REGIONAL REVIEW NOTICE

ARC REVIEW CODE: R1602041

Name of Proposal: Ridgewalk Landing

SUBJECT: **Transportation Division Review of DRI # 2520**

CONCEPTUAL
GRTA DRI
SITE PLAN

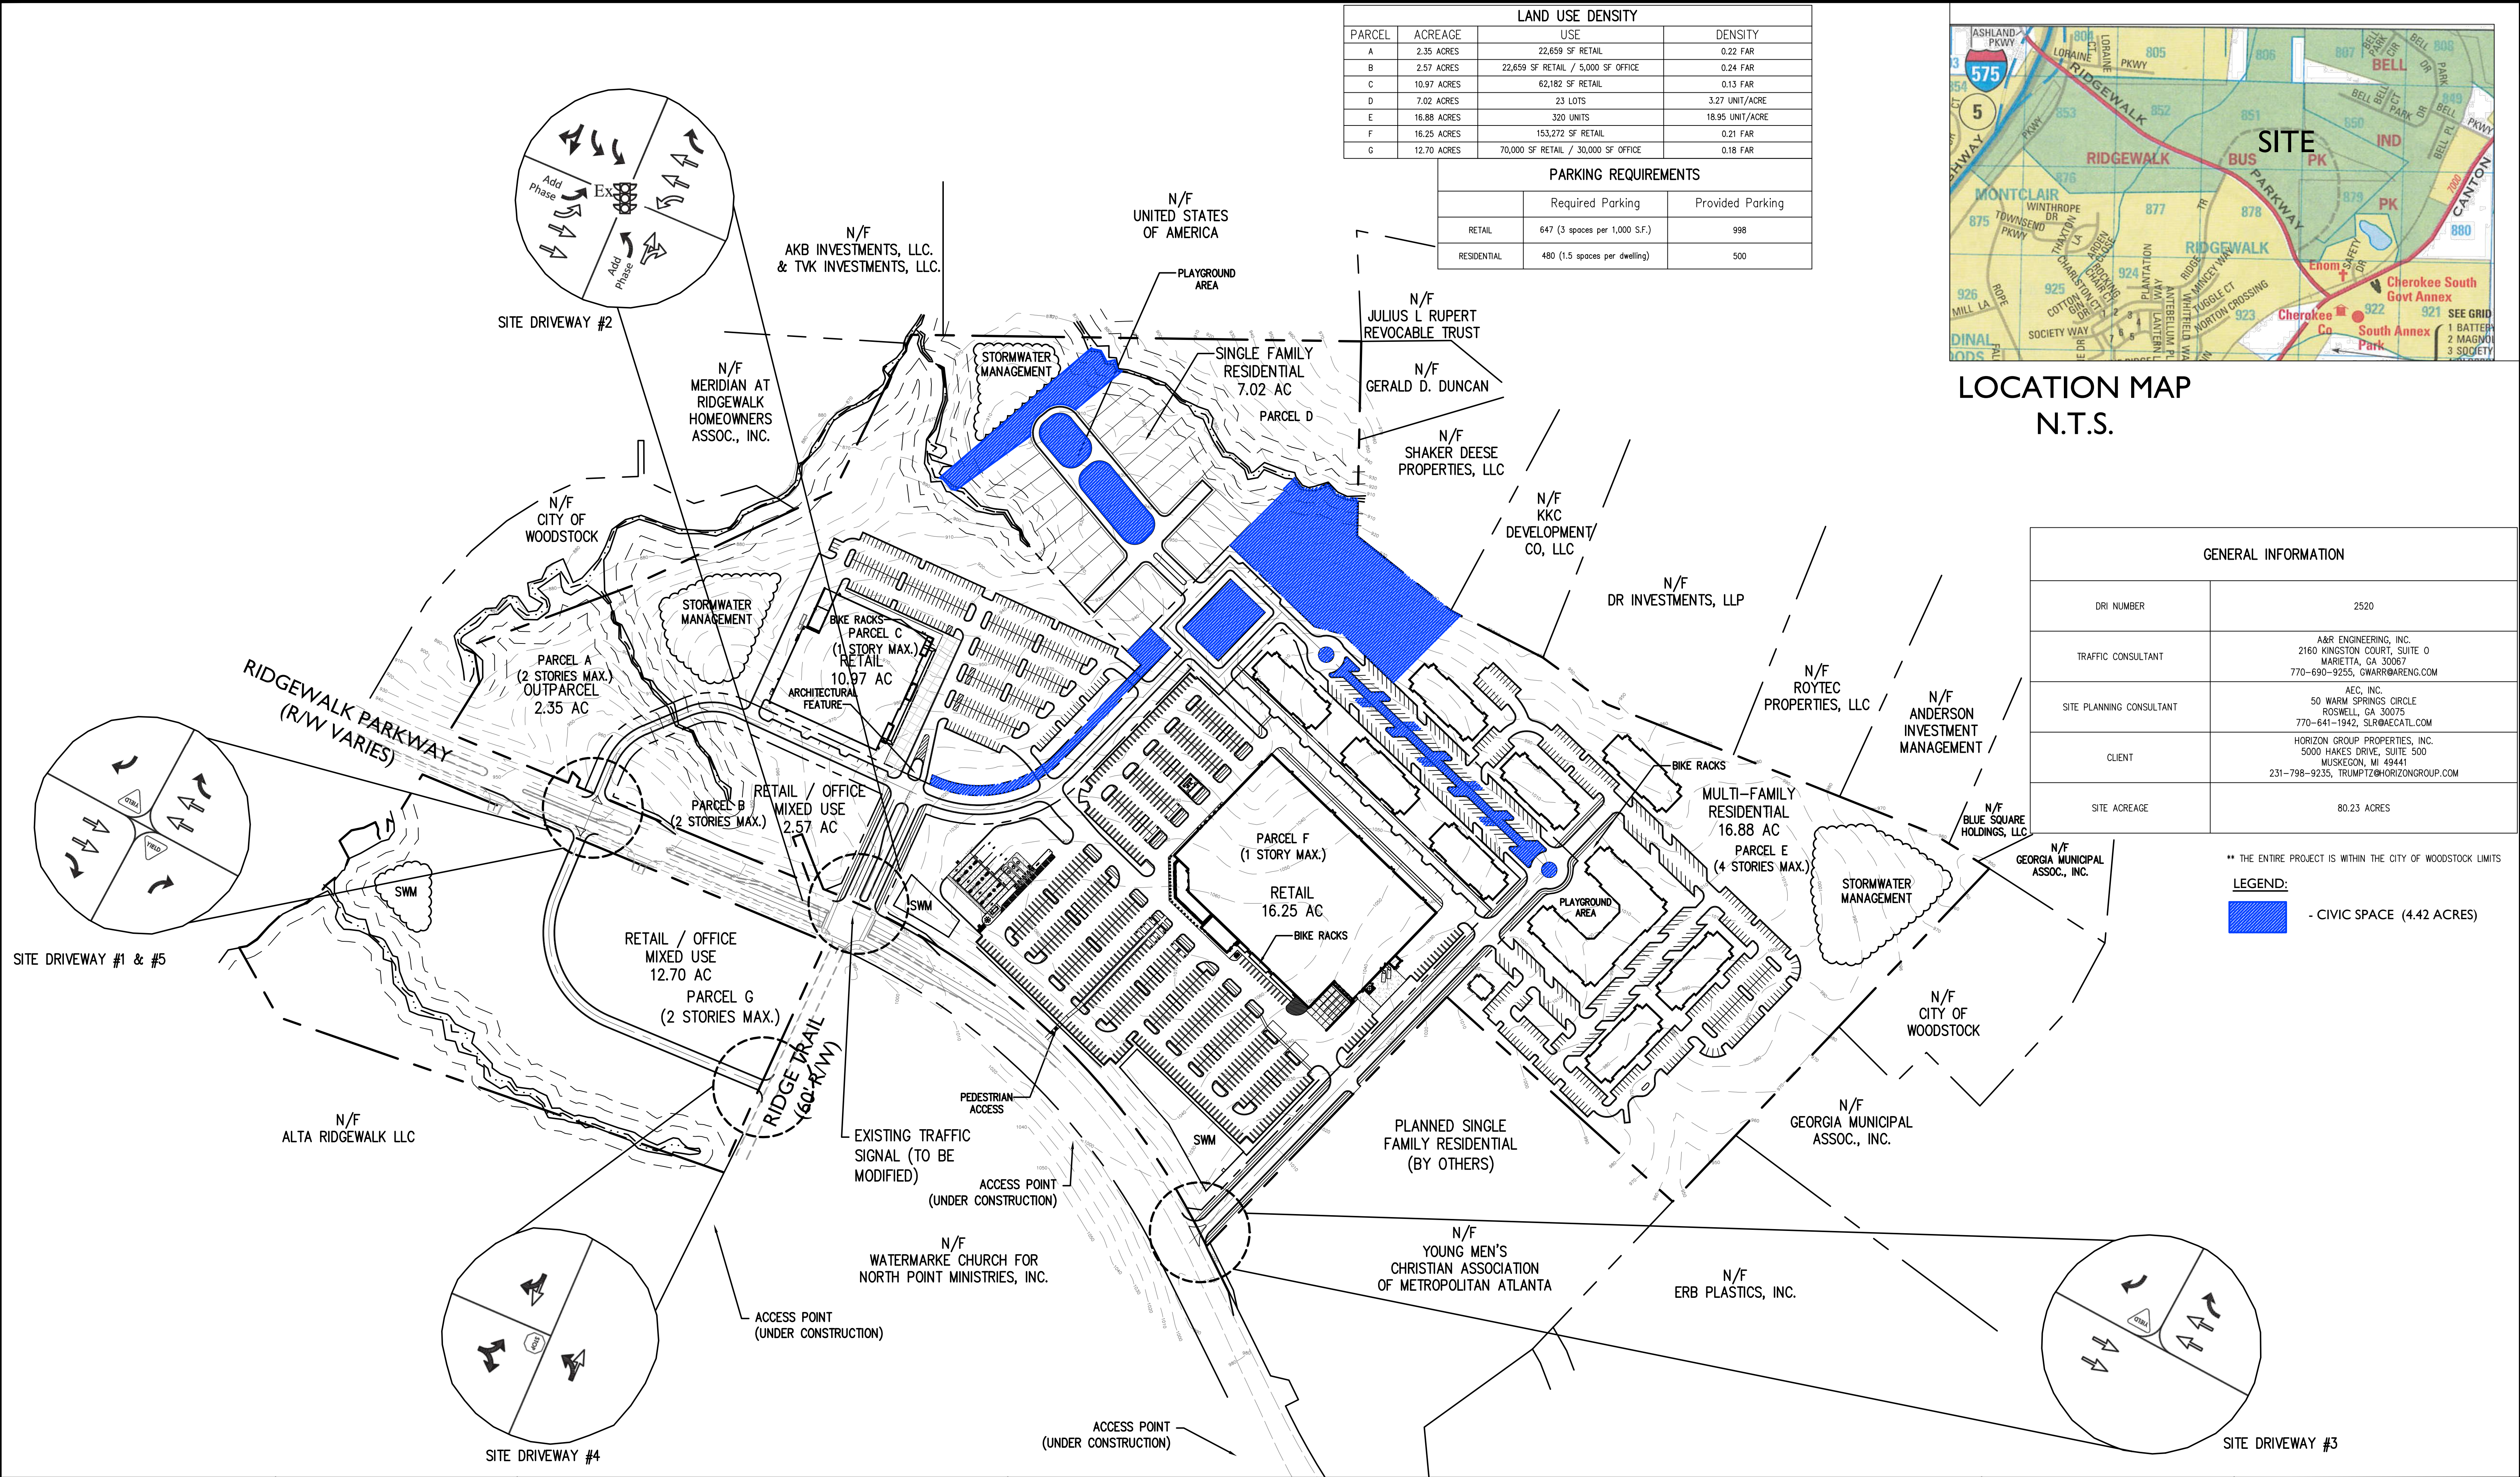
The proposed development plan features a mix of commercial, office, residential and civic space. This format will create the potential for site users to park once and conduct multiple trips on foot. However, commercial uses on either side of the site are separated from each other by large surface parking lots and main site driveways. Care should be taken to ensure that sidewalk connections between these uses and throughout the site are clearly marked, safe and comfortable for pedestrians. This will encourage walking trips between uses, minimizing dependency on cars for internal site circulation. To reduce area-wide traffic and vehicle miles traveled (VMT), the developer should follow through with constructing on-site bicycle parking facilities as planned. The addition of bicycle access into and out of the site – via protected lanes or similar methods – would also help reduce traffic and area-wide VMT while capitalizing on the adjacent Greenprints Trail and Woodstock's overall multi-use trail network. This is something the City and the developer should consider.

The development plan also proposes a large surface parking lot that fronts on Ridgewalk Parkway. While it appears that the lot is planned to sit higher than the level of the Parkway due to site topography, the developer and the City of Woodstock should explore strategies for minimizing the visual impact of this surface parking.

The USGS coverage for the project area shows a blue-line tributary to the Little River (named Bethany Creek per Google Maps) running along the northwestern boundary of the project property. In addition, the submitted site plan shows three tributaries of Bethany Creek extending into the property. What appear to be buffers are shown along the indicated streams, but they are not identified as either the 25-foot State sediment and erosion buffer or the 75-foot City of Woodstock stream buffer. All applicable buffers should be identified and shown to scale. A road crossing is shown across one of the unnamed tributaries and an identified “civic space” extends into the buffer on another. Any proposed intrusion into City of Woodstock buffers may require a variance from the City. Any intrusions into the State sediment and erosion buffer will also require variances.

The applicant should seek the opportunity to tie into roads on properties adjacent to the northern tract to add relief from having to enter/exit Ridgewalk Parkway.
